**ENGINEERING, OPERATIONS AND PLANNING COMMITTEE MEETING  
AGENDA**

**THURSDAY, JULY 25, 2024 - 6:00 PM**

**DATE:** July 25, 2024  
**TO:** Engineering, Operations and Planning Committee  
**FROM:** Rocky Welborn, Director of Engineering  
**SUBJECT:** CHANGE ORDER NO. 5 WITH PCL CONSTRUCTION, INC. FOR THE OLIVER P. ROEMER WATER FILTRATION FACILITY UPGRADE AND EXPANSION PROJECT

## Hand Rail for Stair Well

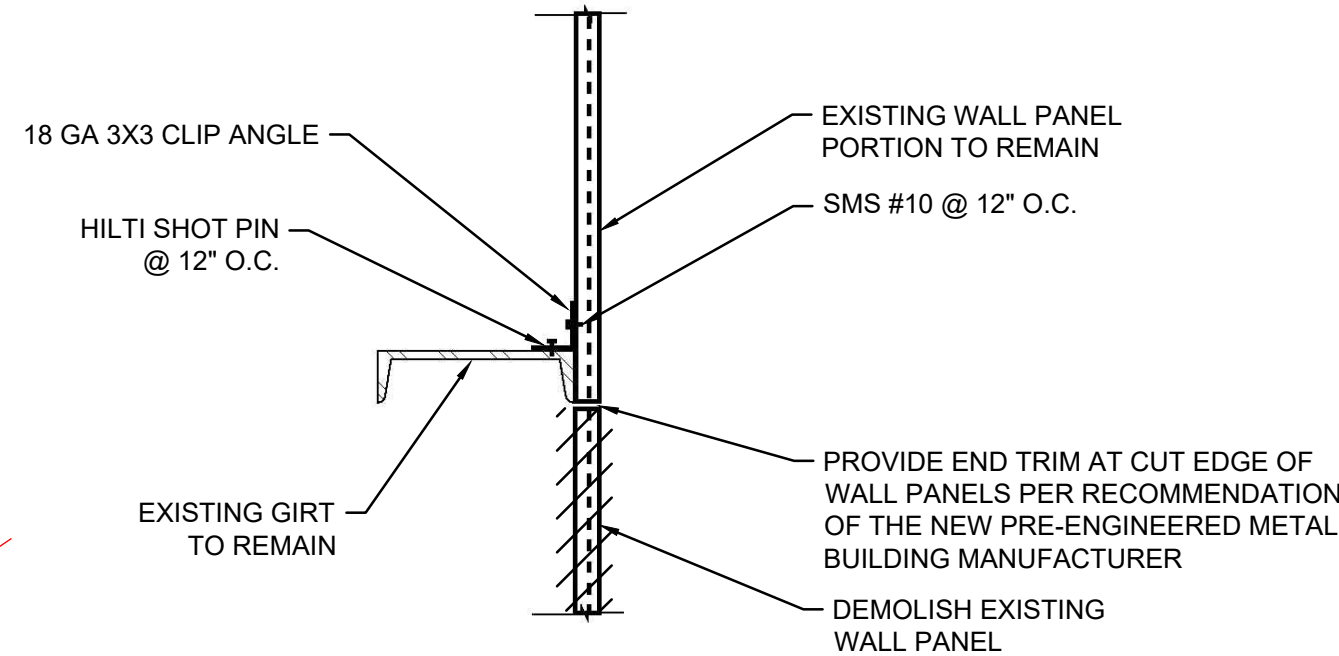
Please accept the attached package as a Change Request for the additional handrail. Per the West Valley Water District's request, additional panels of the existing Filter Building 1 are being deleted by the stairs leading to the basement. In order to address the fall hazard that will be created by the deletion of the panels, a handrailing system is required in the area. Furthermore, PCL's proposal and budget assumed that all panels with cross bracing would be kept in place.

PROVIDE END TRIM AT CUT EDGE OF WALL PANELS  
PER RECOMMENDATION OF THE NEW  
PRE-ENGINEERED METAL BUILDING MANUFACTURER

DEMOLISH WALL PANEL  
TO GRID LINE 10

DEMOLISH  
EXISTING LOUVER

PROTECT IN PLACE  
EXISTING BRACE ROD,  
TO REMAIN

REMOVE WALL PANEL BASE ANGLE AND  
FASTENERS. FILL HOLES AND DIVETS WITH  
GROUT; PROVIDE A FINISH FLUSH WITH  
THE SURROUNDING CONCRETE

Unforeseen Utilities at Pre-Treatment Facility

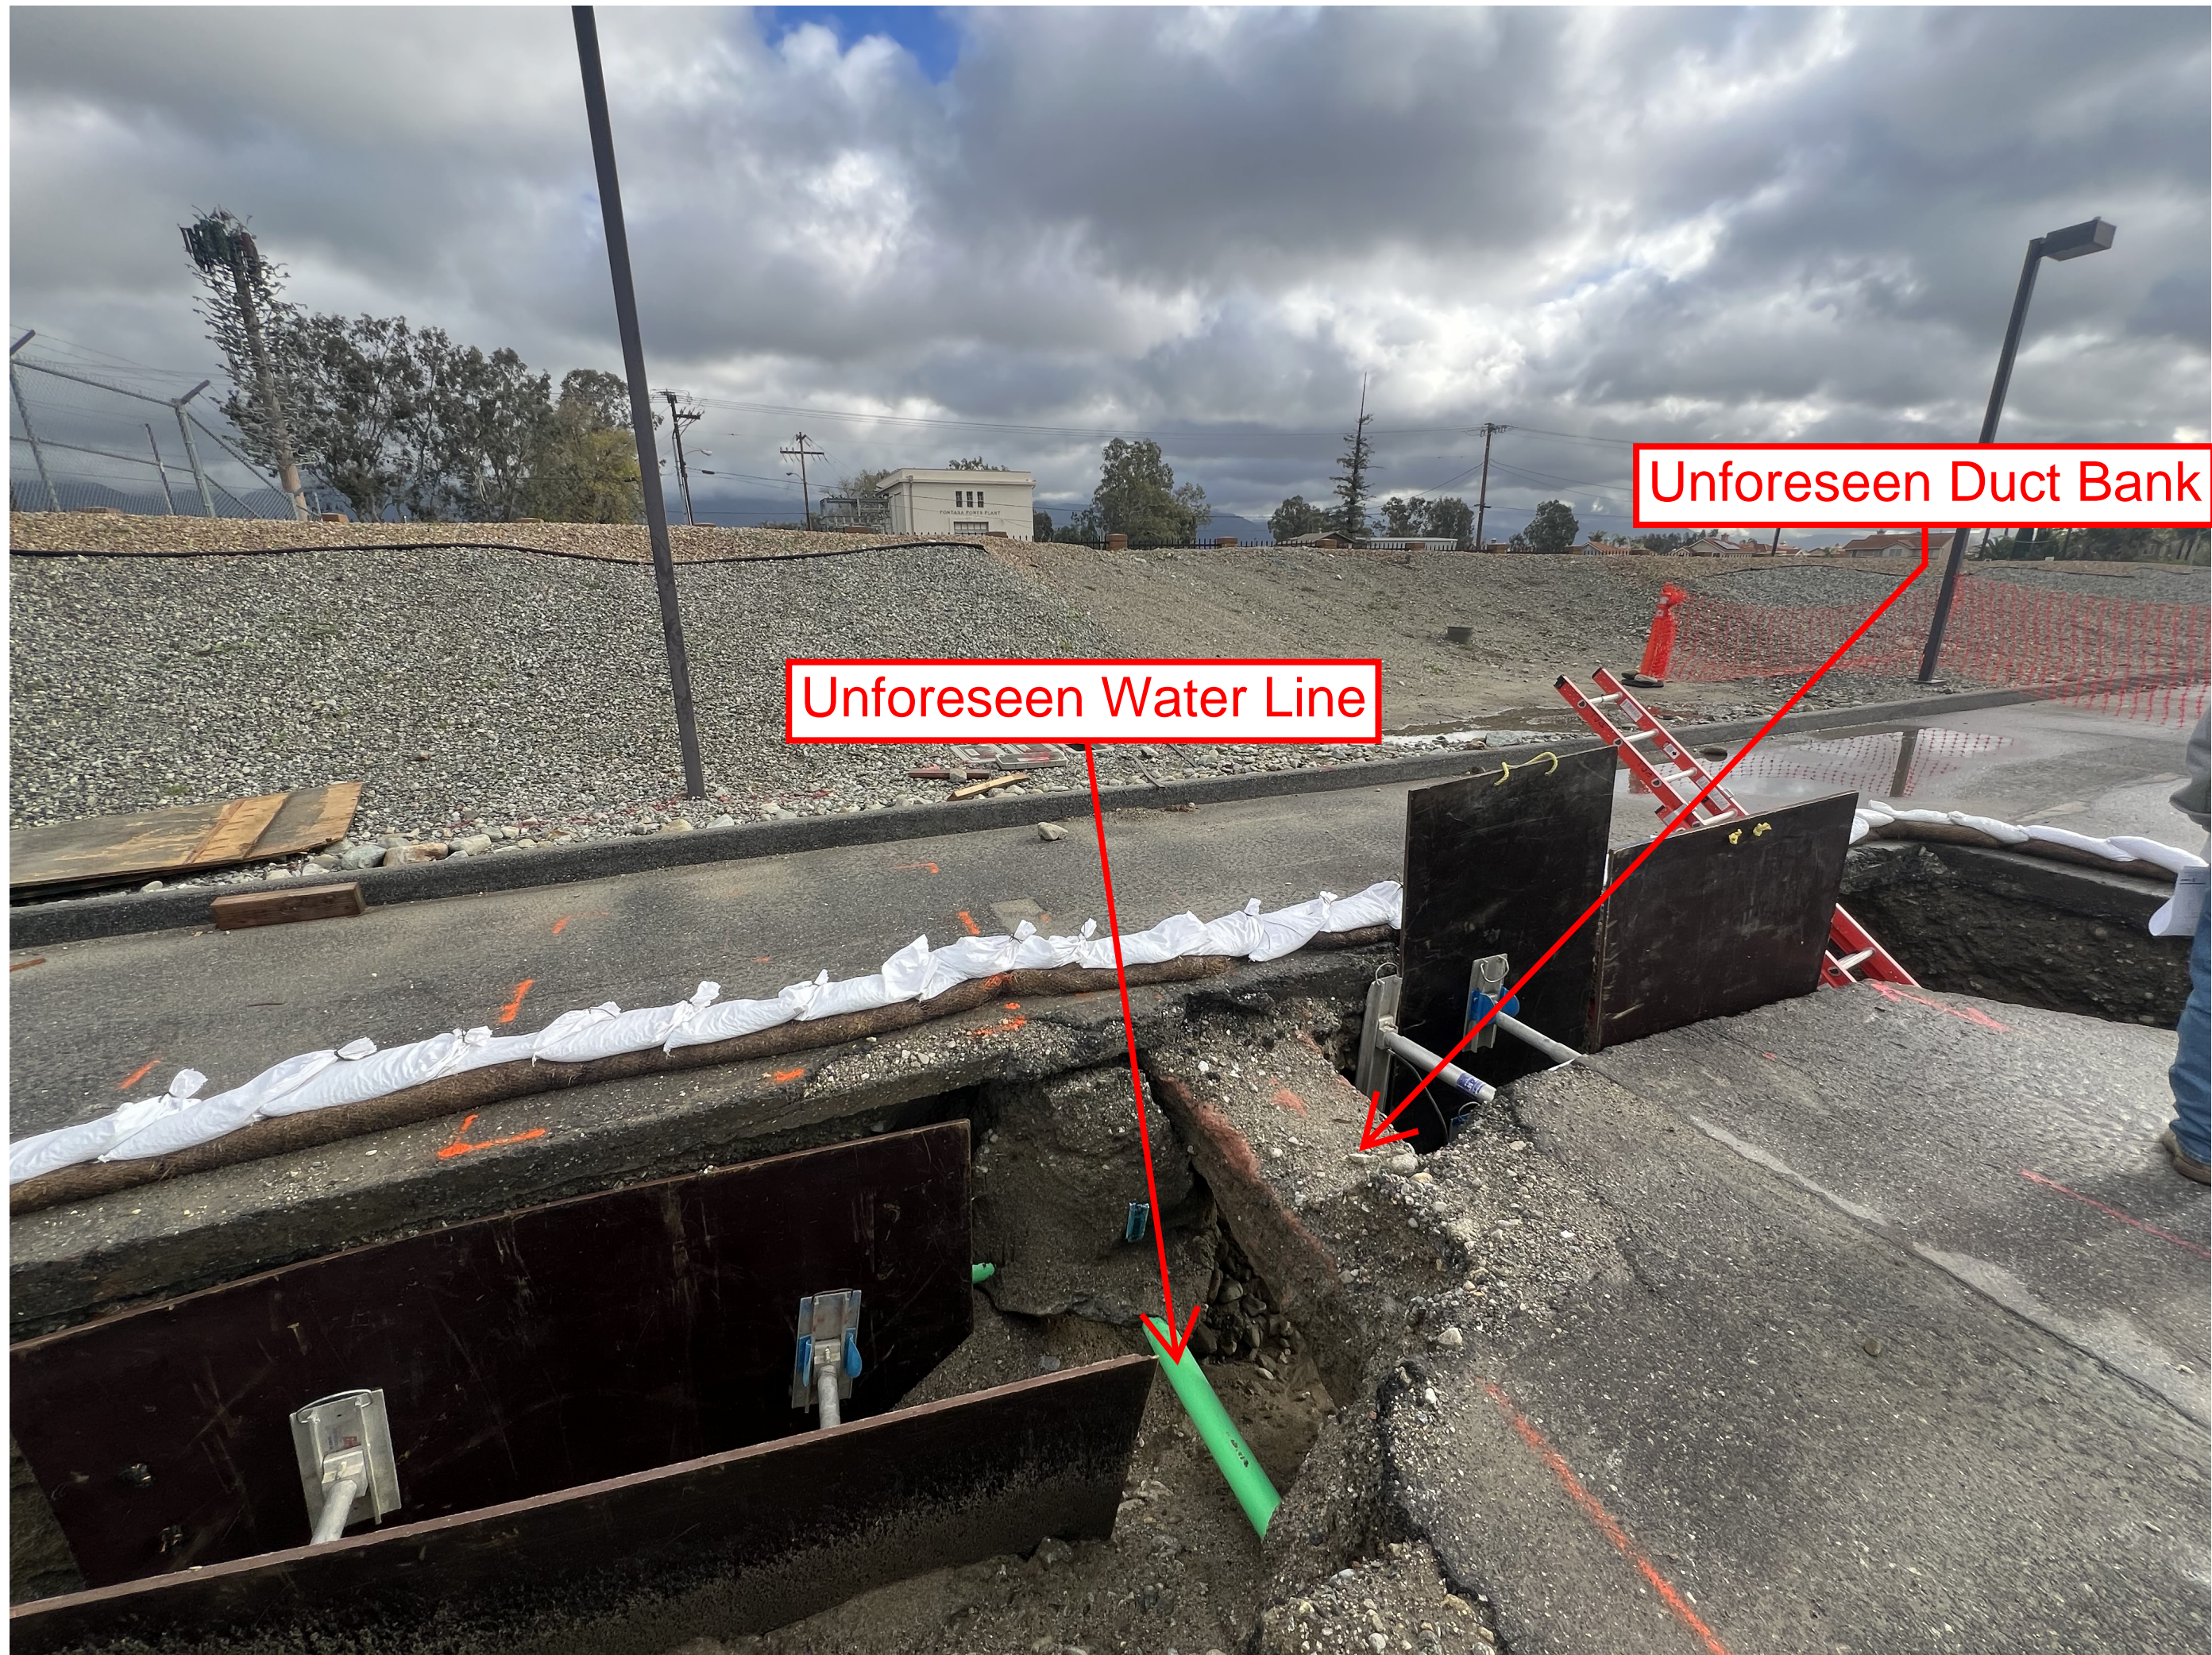
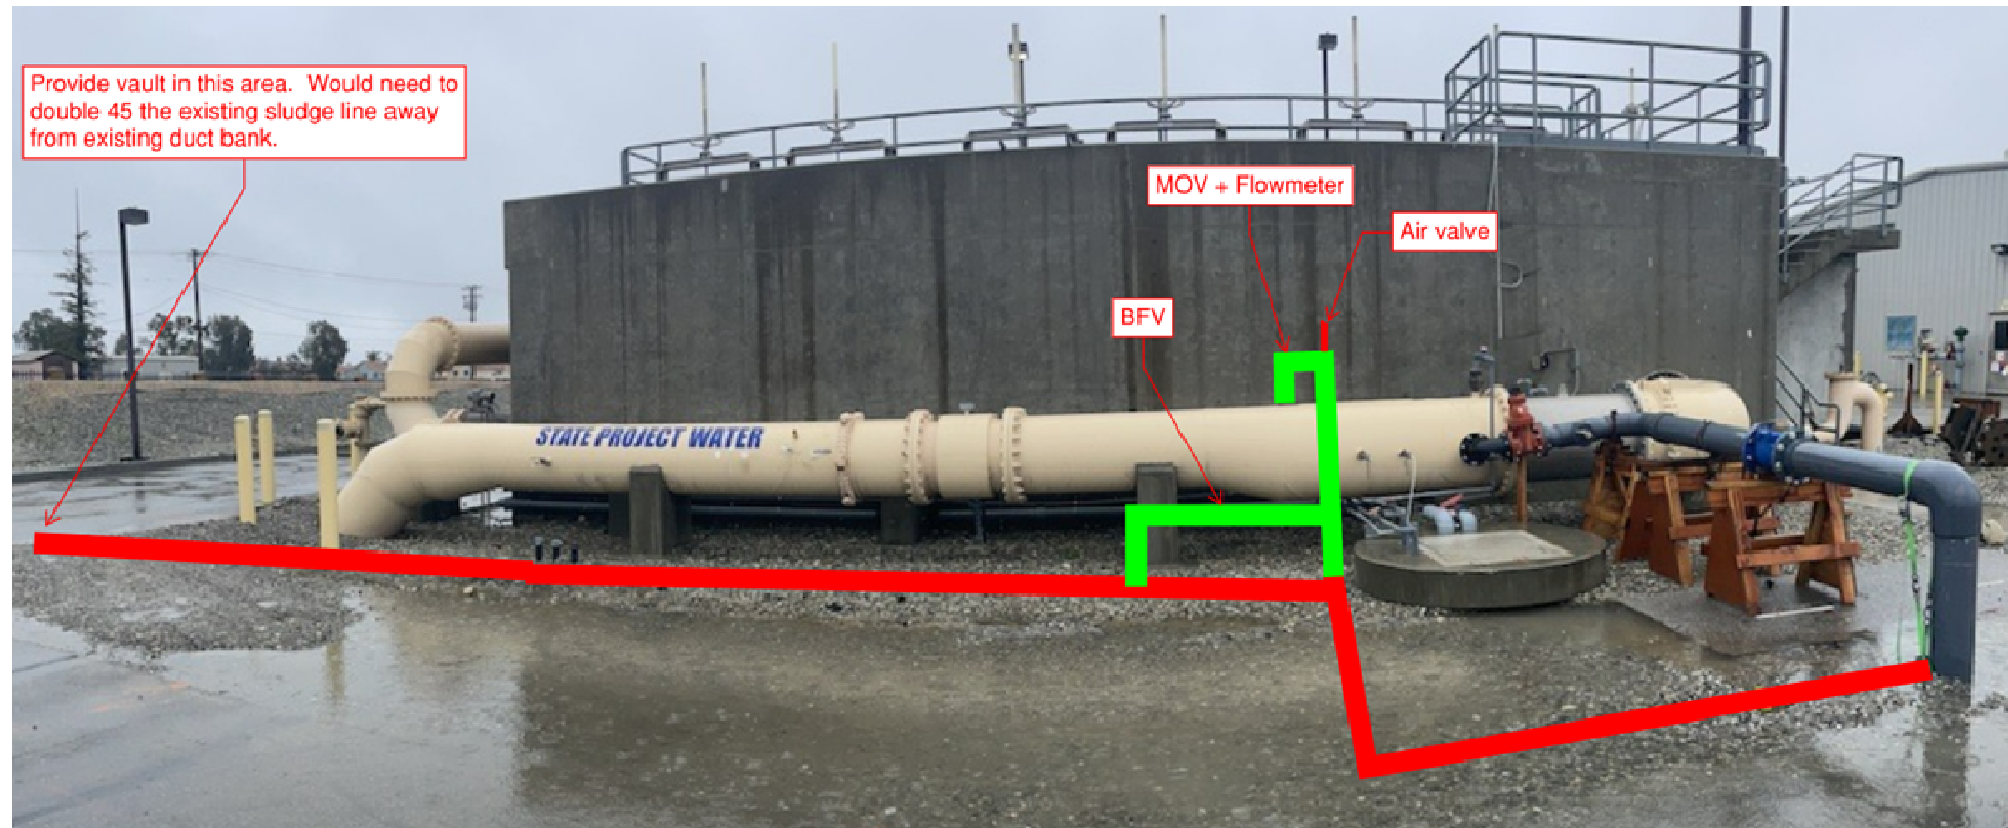
Please accept the attached package as a Change Request due to the cost impacts caused by two unforeseen utilities identified near the Pre-Treatment Facility and a 58-inch-wide duct bank with a differing location than what is shown in the provided record drawings. The two unforeseen underground utilities classified as an abandoned 1-foot 3-inch-wide duct bank and a 4-inch PVC water line were discovered during the installation of duct bank's (DB) 06 and 08, preceding the installation of the 12" backwash recycle line (12" REC) connecting backwash ponds 1-6 to the Pre-Treatment Facility. The record drawings provided at the time of proposal do not show any of these unforeseen lines. Due to these unforeseen utilities' location additional design and construction efforts are required to finalize the routing of DB-06 & 08 and the remainder of 12" REC line left to be installed beyond the temporary bypass currently in place. From potholing it was determined the 58-inch-wide duct bank has a differing location than what is shown in the record drawings. The 58" wide duct bank's actual location would not allow for the installation of the check valve vault needed to house the future sludge line check valve.

- The unknown 4-inch PVC line location led to an updated design to the above ground pipe needed for the 12-inch butterfly valve's and Air Vac assemblies. Due to the depth of the 4-inch PVC line where the 12" REC was intended to cross, a drastic dive in elevation would be needed creating deeper excavations for the 12" REC before extending above ground as shown in the IFC drawing sets. To avoid this additional depth or a reroute of the 4-inch PVC line an updated design was proposed to avoid this crossing entirely which also would allow for the original asphalt road width at sludge pond 3. This preference was discussed with WVWD plant operators, GHD and Stantec prior to moving forward with it's design.
